November 10, 2025 PLANNING DEVELOPMENT AND ZONING MEETING

NOTICE OF A MEETING
MANVEL PLANNING DEVELOPMENT AND ZONING COMMISSION
November 10, 2025

STAFF REPORT TO PLANNING, DEVELOPMENT AND ZONING COMMISSION
PLAT APPLICATION

Plat Name:	Avellino Section 2- Final Plat
Applicant:	Kaitlin Gile – EHRA Engineering
PD&Z Meeting Date:	November 10, 2025
Submitted By:	Ellie Roohbakhsh, Senior Planner
Report Approved by:	Dan Johnson, City Manager/ City Engineer Jose Abraham, Director of Development Services
Recommendation of Approval:	Conditional Approval

FINAL PLAT OF
AVELLINO
SECTION 2

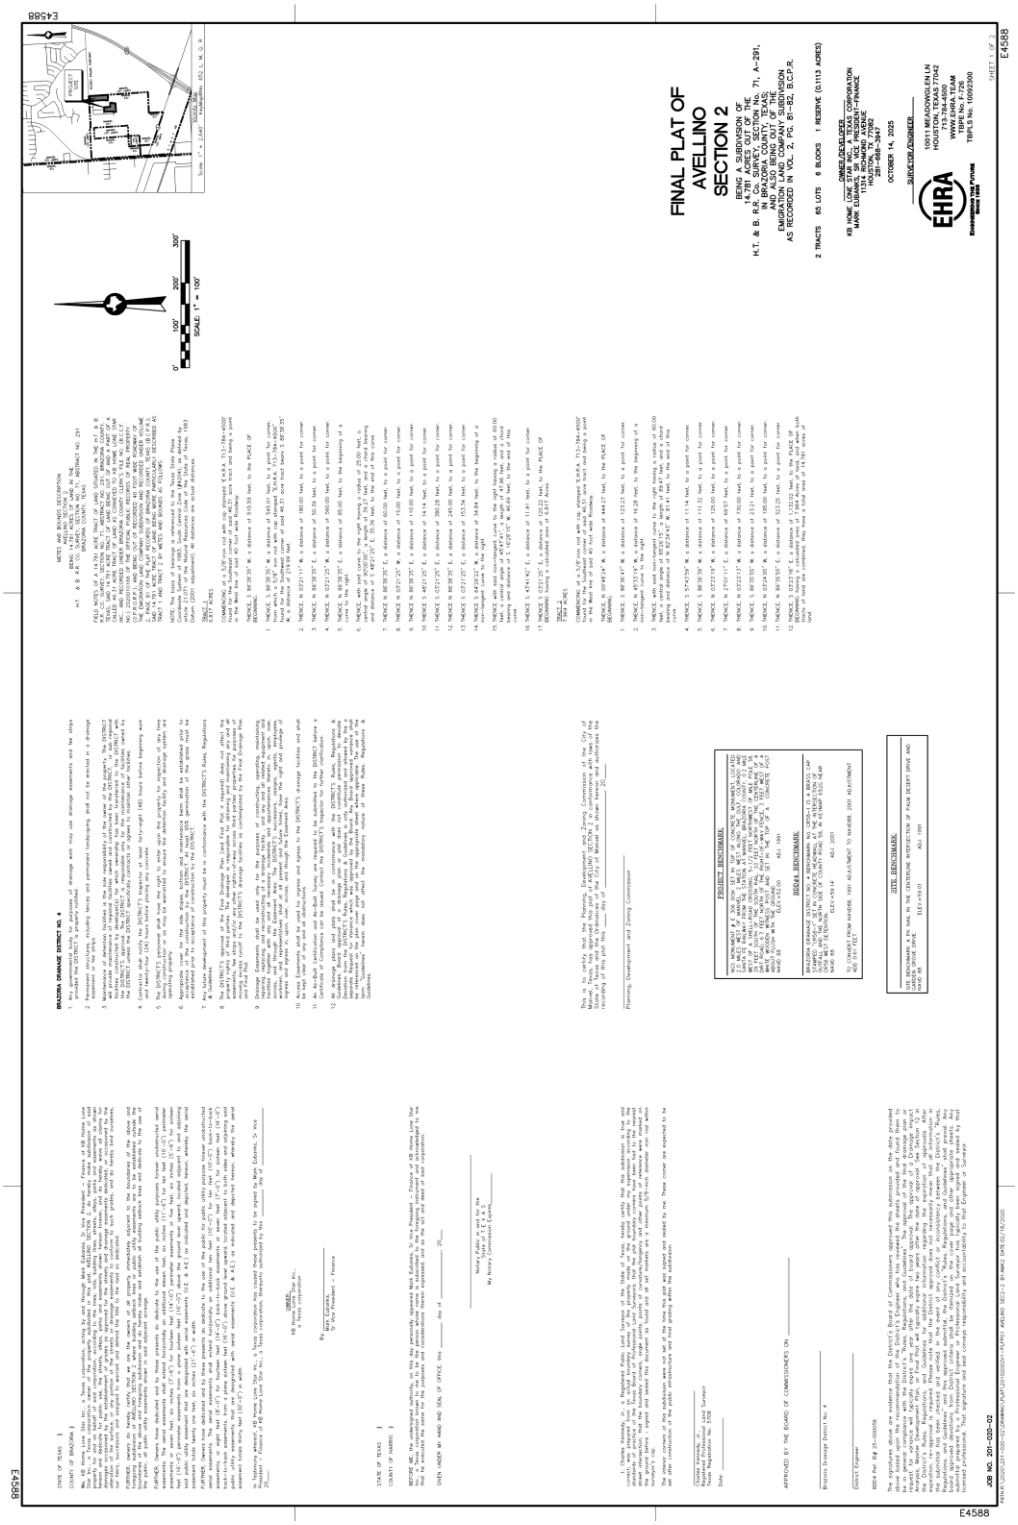
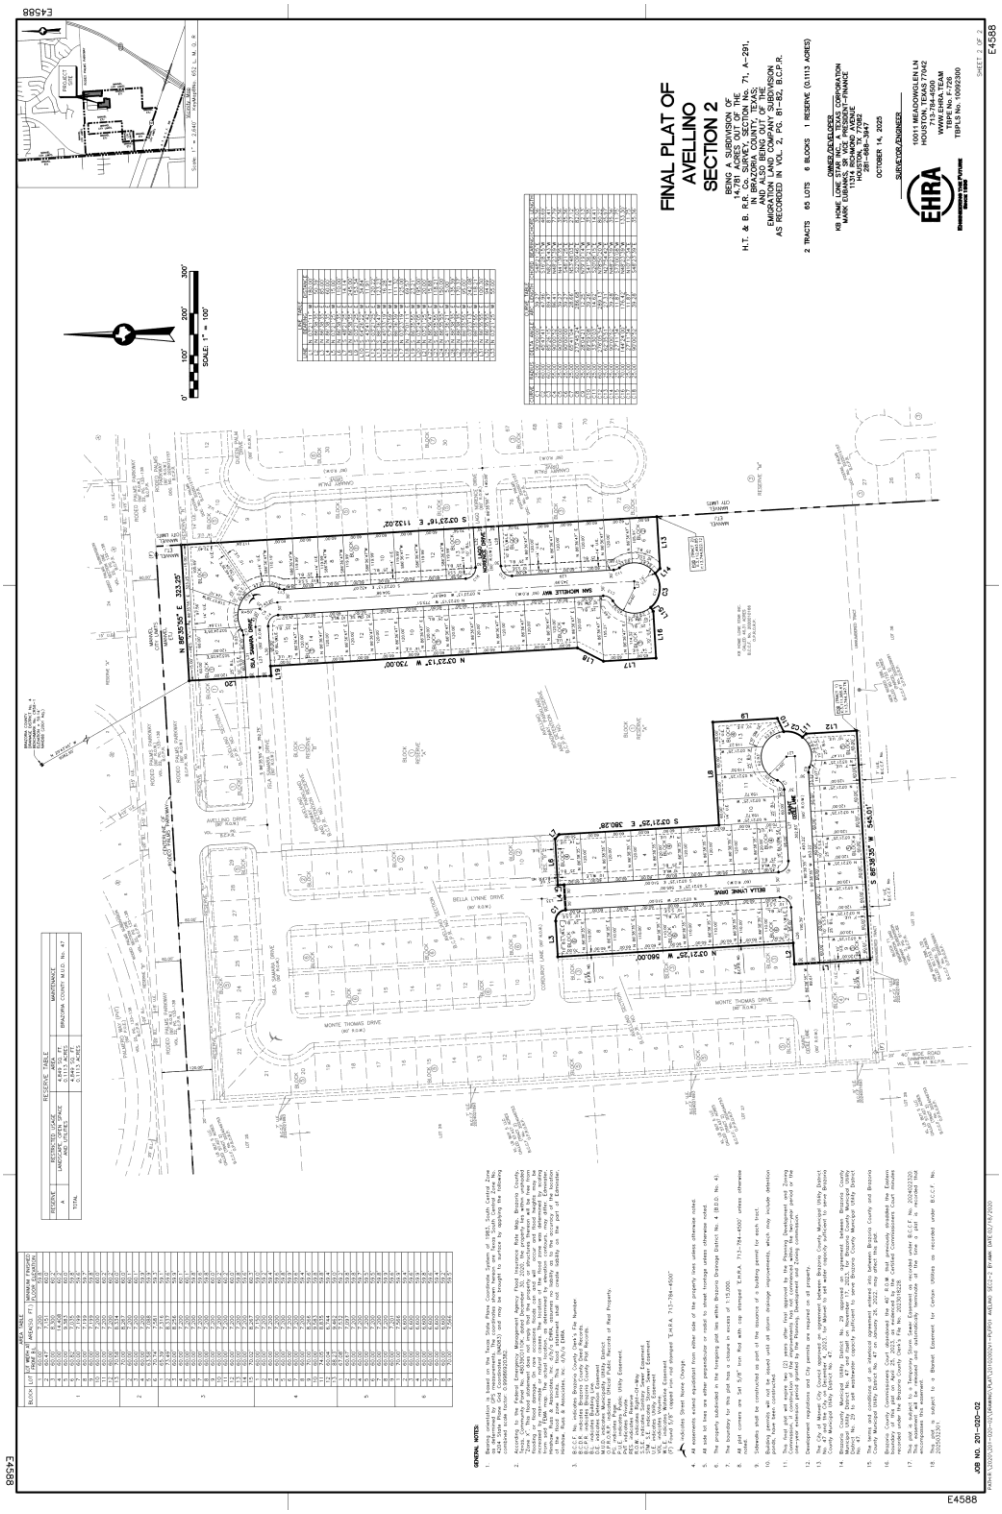
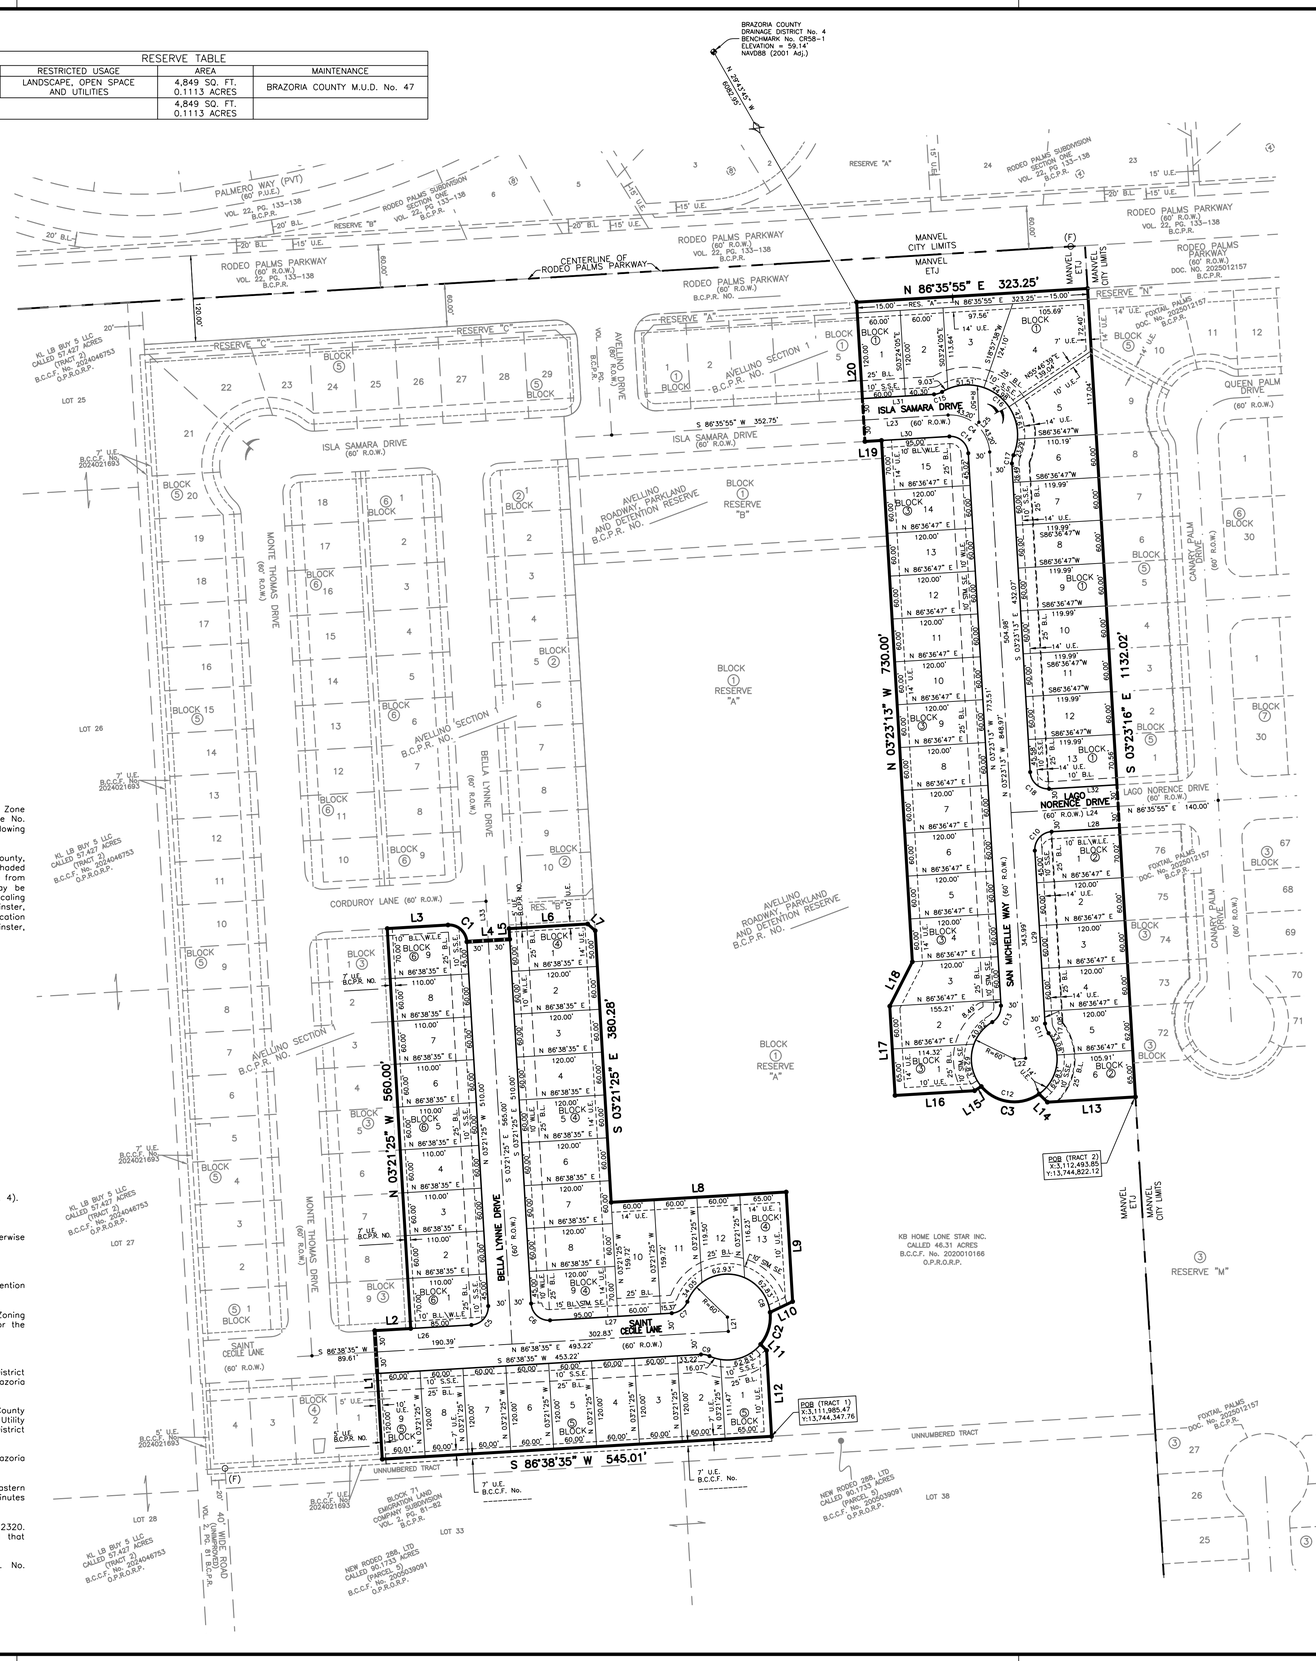
1. Provide signature of the Registered Professional Land Surveyor on the face of the plat (Mylar and electronic copies) (Section 62-38 (b)(4)).
2. Provide property owner's signature and associated notary signatures on the face of the plat (Mylar and electronic copies) (Section 62-38 (b)(6))
3. Please clarify if the radii for Curves C4 and C16 are correct (Section 62-38 (b)(10)).

4. Revise to fill in the blank spaces to include document numbers for adjacent subdivisions or remove references to them and mention them as Future development (Section 62-38 (b)(11)).

5. Please revise to:
   a. Show a STM SE in Lot 1, Block 4 for the storm line to be installed per approved civil plans.
   b. Show the WLE in Lot 9, Block 6 extending to the property line along Bella Lynne Dr.

c. Include a combination WLE/STM SE in Lot 1, Block 3.
   d. Change the SSE in Lot 6, Block 2 to a WLE to match the approved civil plans.
   e. Show the 10' UE along the south property line of Lot 6, Block 2 as indicated on the approved civil plans.

f. Indicate a 14' UE in front of lots fronting San Michelle Way on the east side.
   g. Show a rear 7' UE for lots fronting San Michelle Way on the east side (see markups for reference).

h. Extend the STM SE for lots fronting San Michelle Way on the west side to begin before the Lot 14/15 boundary.
   i. Show the Temporary Storm Sewer Easement referenced in Note 17 of the General Notes on the plat (Section 62-38 (b) (13)).

6. Indicate the MUD boundary lines, and add a note referencing the City Council approved Variance on the Plat with the Development Agreement recordation number 2025039915. Additionally, please revise the BDD4 Benchmark Note to include "… at the intersection of Outfall A…" for to match the Data Sheet (Section 62-38 (b)(18)).

7. Although the drainage plans have been approved by the drainage district, since the property is located within the City's ETJ, please provide the Drainage District signatures on the plat (Section 62-38 (b)(19)).

Plat Exhibit

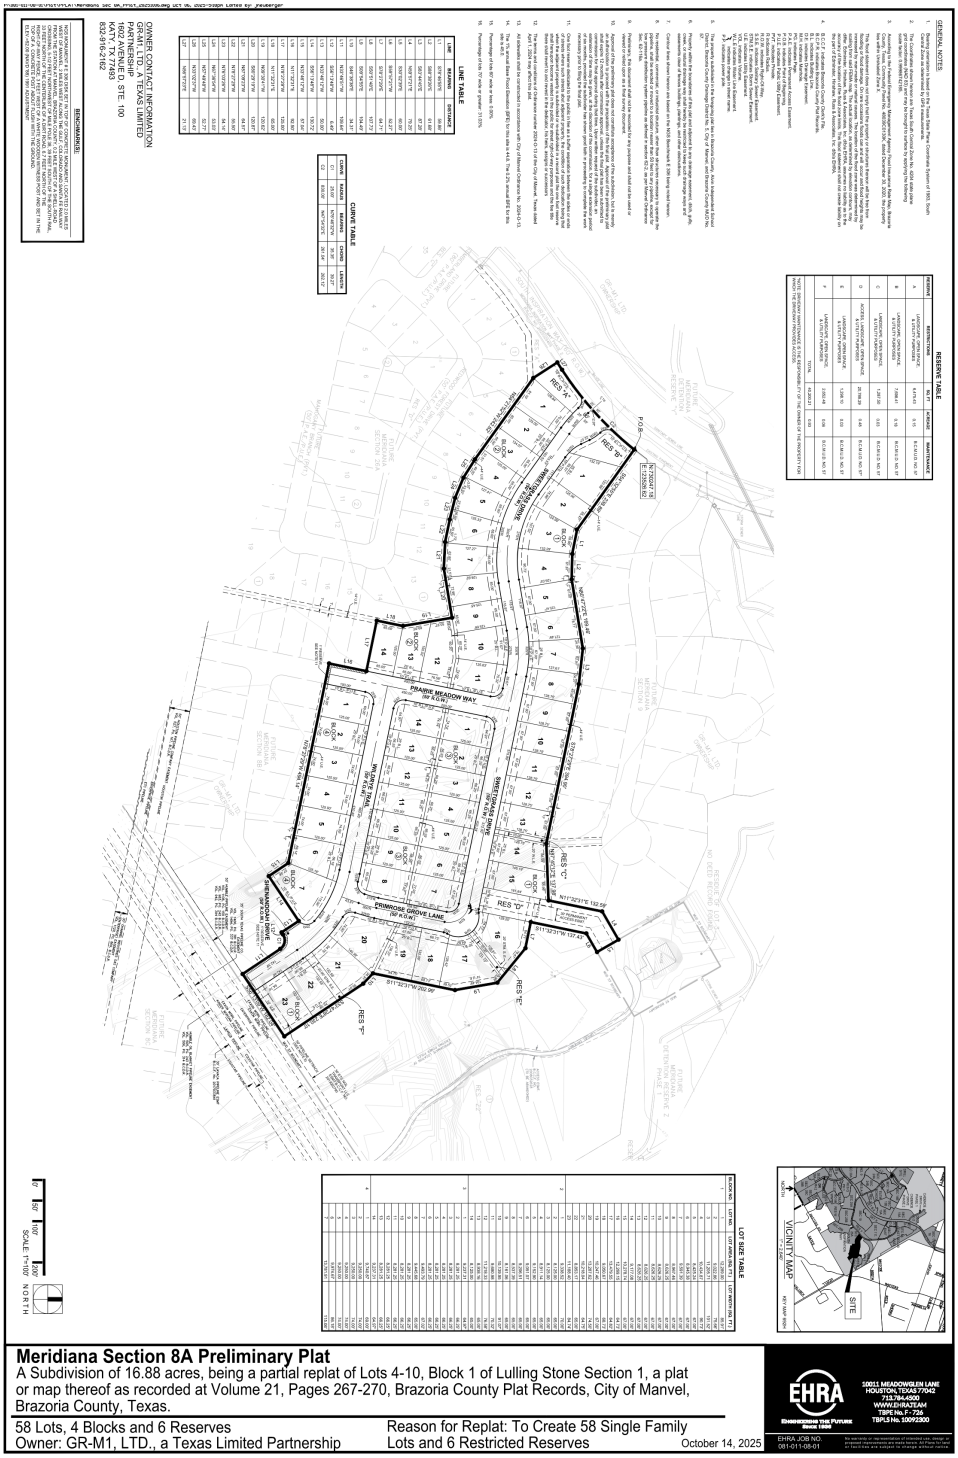
1. Please have the detention ledger in the drainage exhibit and the acreage shown on the plan view of the exhibit consistent with the submitted plans for the Pond Z expansion (Section 62-38 (a)(12)).

Plat Exhibit

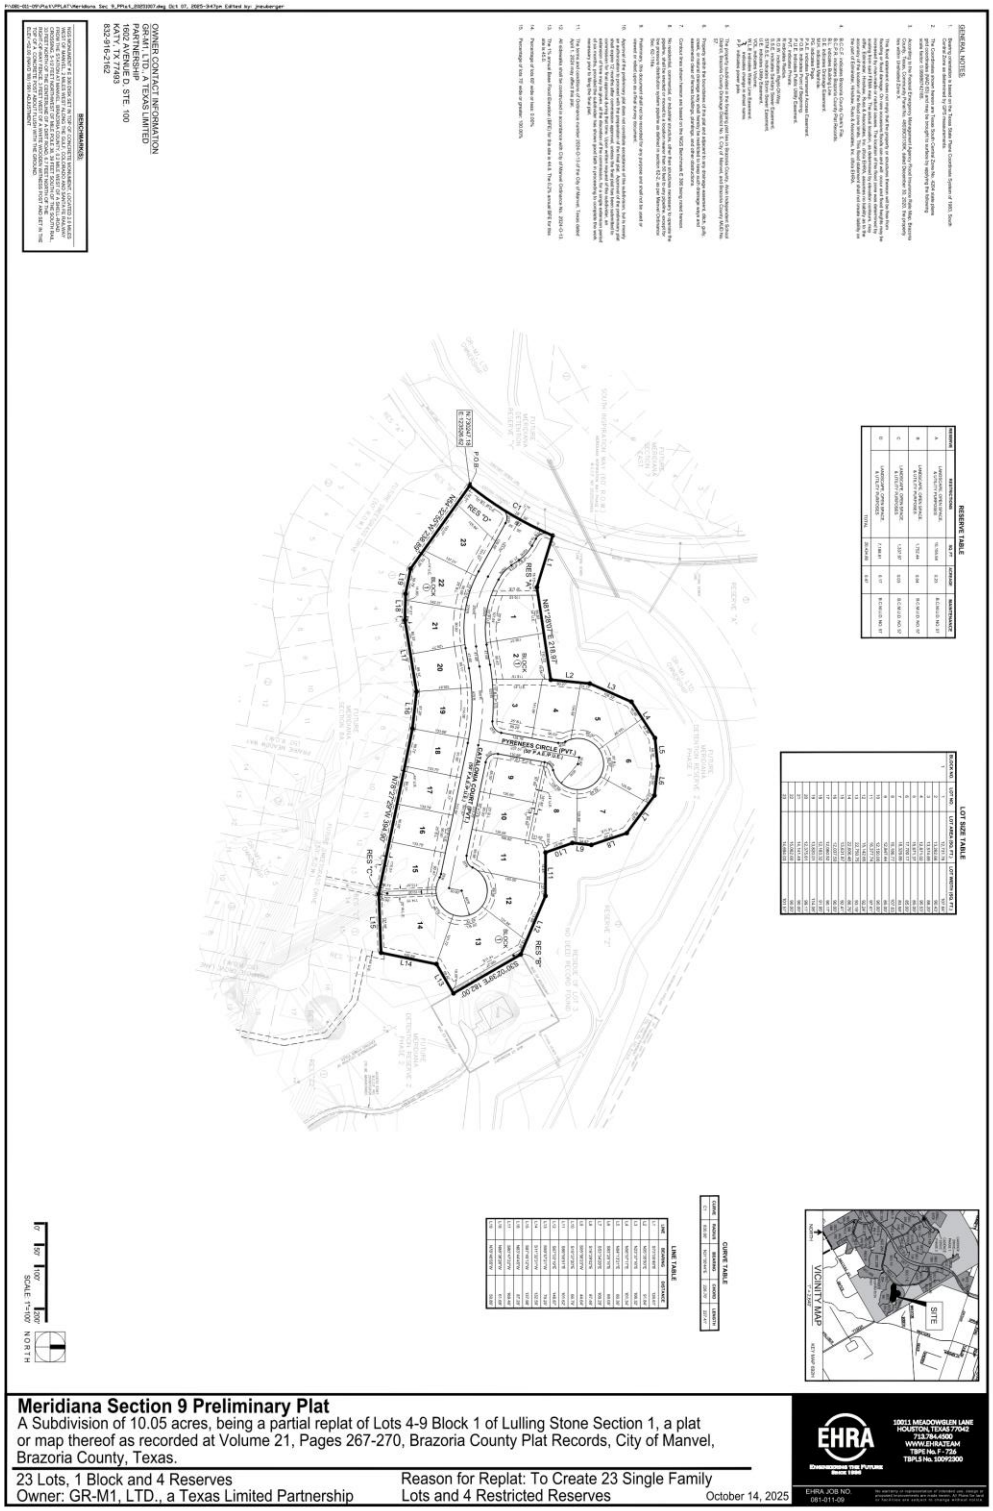
1. Please label all with pipe sizes, grades within 200 feet of tract such as water and storm sewer near the northern boundary (Section 62-38 (a)(7)).
2. Please ensure the PUE in Reserve A along S Inspiration Way covers the utility lines (Section 62-38 (a)(9)).
3. Per Approved PUD, local streets shall have a minimum right-of-way width of 60 feet within single family sections in which 50% or more of the lots are 70 feet wide or greater. Please revise to meet this requirement (Section 62-38 (a)(9)).
4. Please have the detention ledger in the drainage exhibit and the acreage shown on the plan view of the exhibit consistent with the submitted plans for the Pond Z expansion (Section 62-38 (a)(12)).

Plat Exhibit

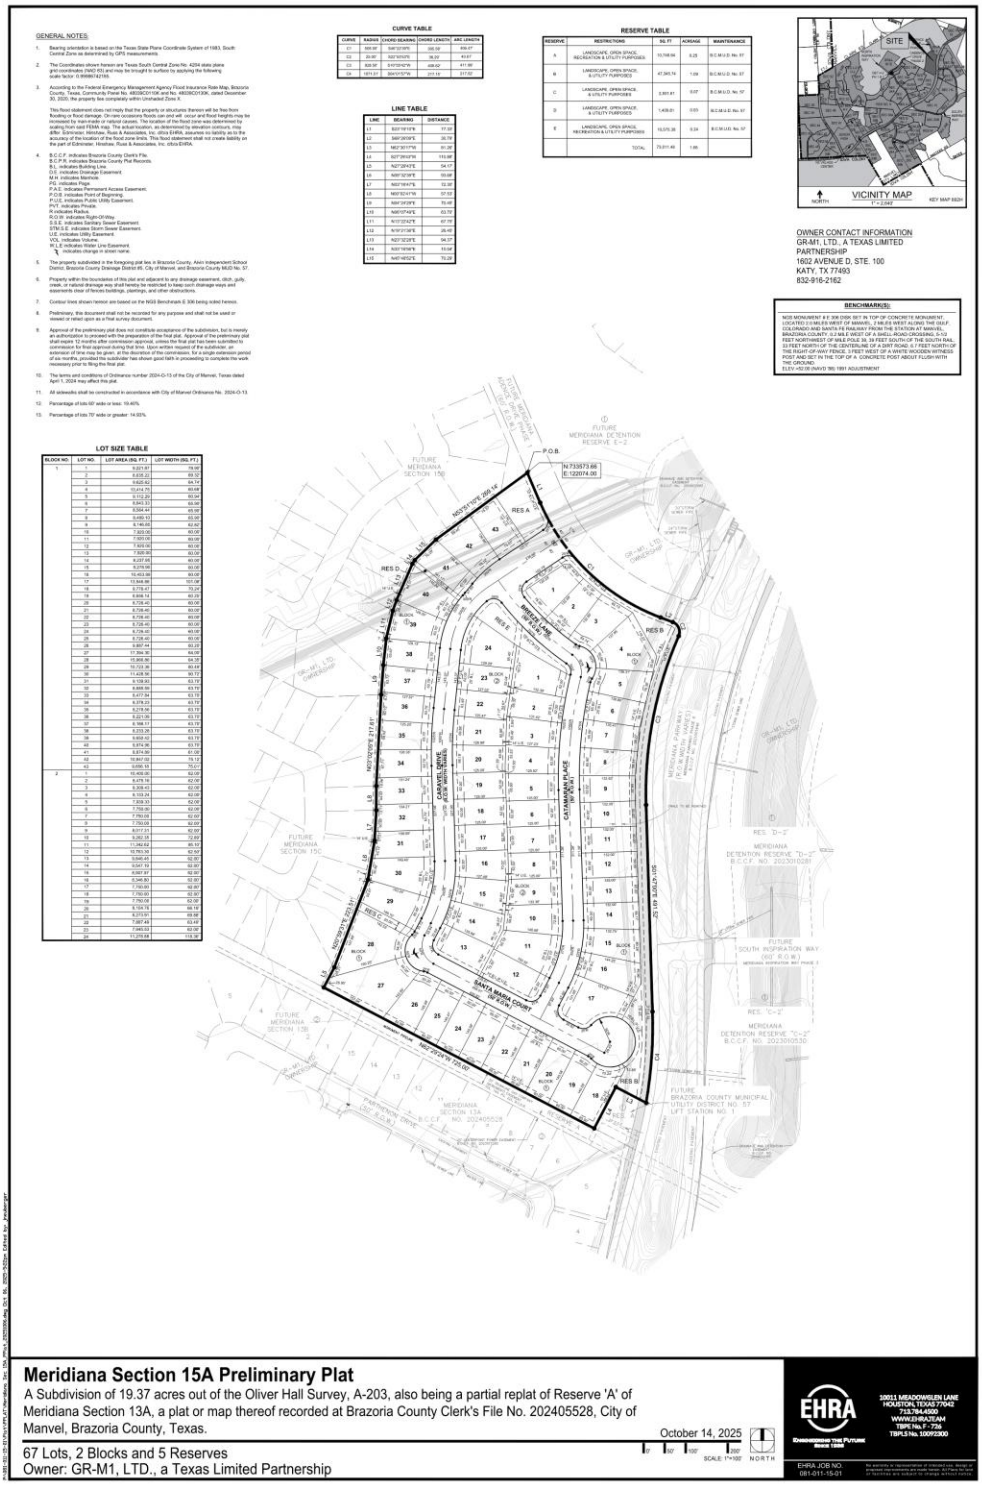
1. Please verify that the bearings along all shared boundaries, including those shared with the 13A plat, the Lift Station No. 1 plat, and the Cadence Drive Phase 1 plat, as well as the length of line L4 shared with the Lift Station No. 1 plat, are consistent (Section 62-38(a)(4)).
2. Please verify that all existing utilities are shown within 200’ of the project. Specifically in the area around the lift station/13A (Section 62-38 (a)(7)).
